Date: 09 October 2025
Ref.: CVLNCCP03-G1-02
Email: cvltrackaccess@amey.co.uk

CVL Network – Network Code Condition G1 Network Change Proposal:
CVL Transformation programme combined consultation - EE4 Energisation and Ty-Glas Station Platform Extension

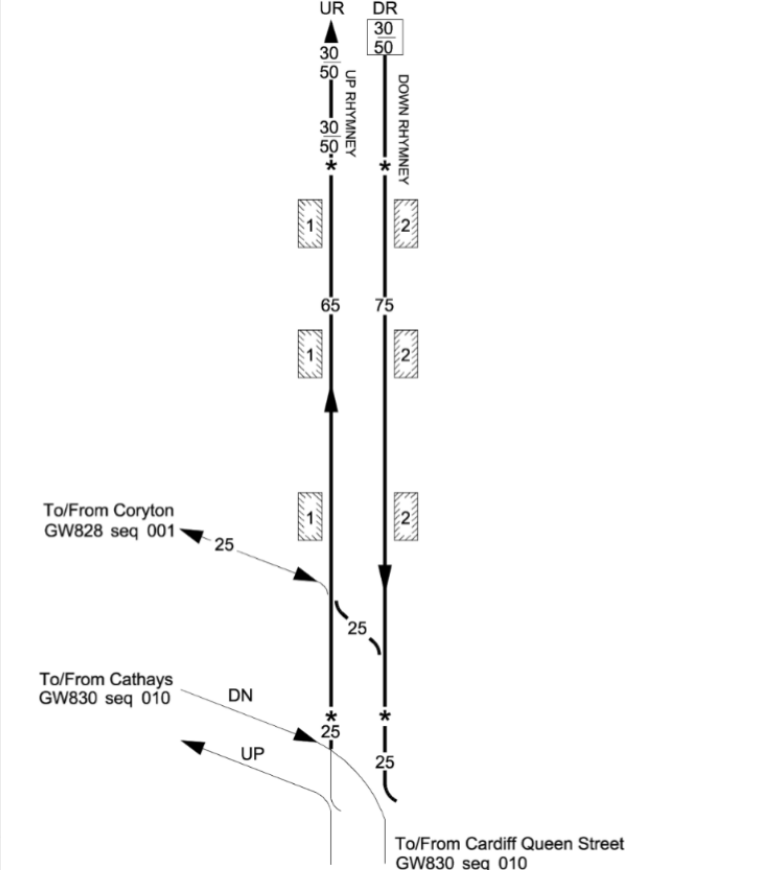
55mph Permanent Speed Restriction (“PSR”) on the up at Llanbradach moved 5 chains north.

Amendments to Sectional Appendix

To support the alterations described above, the following revisions will be made to the Western Route Sectional Appendix GW 810 sequence 001 – 006.

The new requirements are shown in **Red** font whilst requirements that are to be removed are shown in **Green** font struck through. Explanatory notes are in **Blue** font.
